Access Compliance Report

Public Rights-of-Way

Intersection ID: 29427	Main Street: BRADSTREET_COMMONS_WY	Cross Street: SHINY_MEADOW_LN	Location: E
ADA ID: 3343E8A69CFE	Ramp Type: Perp	Initial Pass/Fail: Pass	Overall Compliance: No
Severity Score: 0			
Codes/Mitigation Info/Possible Solution		Field Measurements/Component Compliance

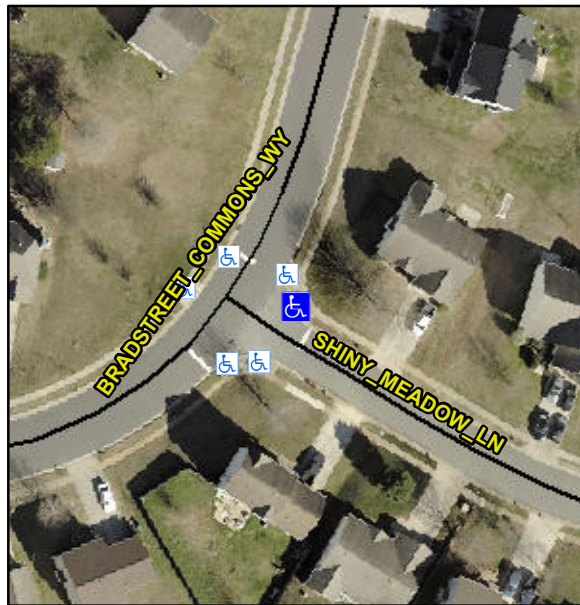
Not Found, R304.2.1, R304.2.2-Perp, R304.3.2-Para

Compliance	Description	Data	Compliance	Description	Data
N/A	Ramp Length (in)	48.0	Yes	Ramp Slope (%)	7.9
Yes	Ramp Width (in)	48.0	Yes	Ramp XSlope (%)	0.9
N/A	Flare Type LT	Sloped	N/A	Flare Type RT	N/A
N/A	Flare Slope LT (%)	2.8	N/A	Flare Slope RT (%)	6.5
N/A	Flare Traversable LT?	No	N/A	Flare Traversable RT?	No
No	Landing Length (in)	48.0	Yes	DWS Provided?	Yes
Yes	Landing Width (in)	48.0	Yes	DWS Contrast?	Yes
No	Landing Slope (%)	2.7	Yes	DWS Length (in)	24.0
Yes	Landing X Slope (%)	0.9	Yes	DWS Full Width?	Yes
N/A	Landing Curb? (Y/N)	Yes	Yes	DWS Offset (in)	2.0
N/A	Shared Landing?	Yes			
Yes	Gutter Ponding?	No	Yes	Gutter Slope (%)	2.8
Yes	Gutter Lip Ht (in)	0.0	Yes	Gutter X Slope (%)	0.3
N/A	Painted X Walk1?	No	N/A	Painted X Walk2?	N/A
	X Walk 1 Direction	To SW		X Walk 2 Direction	N/A
N/A	X Walk 1 Width (in)	N/A	N/A	X Walk 2 Width (in)	N/A
	X Walk 1 Slope (%)	1.5		X Walk 2 Slope (%)	N/A
	X Walk 1 X Slope (%)	2.2		X Walk 2 X Slope (%)	N/A

N/A	Ramp inside XWalk1?	N/A	N/A	Ramp inside XWalk2?	N/A
	Road Slope (%)	N/A	N/A	Clear Space?	Yes
	Road X Slope (%)	N/A	N/A	Clear Space to XWalk (in)	N/A
Yes	Any Obstructions?	No	Yes	Storm Grate/Utility Hazard?	No
	Obstruction Type			Storm Grate/Utility Type	
		N/A			N/A
			Yes	Surface Condition? (G/P)	Good

Remove & Replace Entire Ramp.
